Informal document No. **GRSP-46-40**
(46th GRSP, 8 - 11 December 2009,
agenda item 8)

REGULATION No. 11
(Door latches and hinges)

Proposal for the 04 series of amendments to Regulation No. 11

Submitted by the expert from the European Commission */

Model A

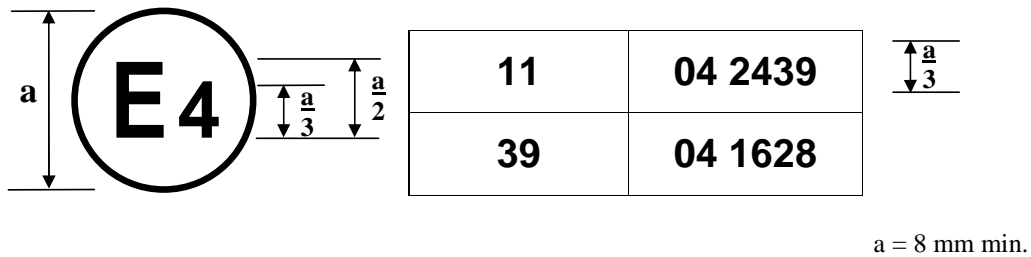
Annex 2, amend to read:

The above approval mark affixed to a vehicle shows that the vehicle type concerned has, with regard to door latches and door retention components, been approved in the Netherlands (E 4) pursuant to Regulation No. 11, under approval number 042439. The first two digits of the approval number indicate that the approval was granted in accordance with the requirements of Regulation No. 11 as amended by the 04 series of amendments.
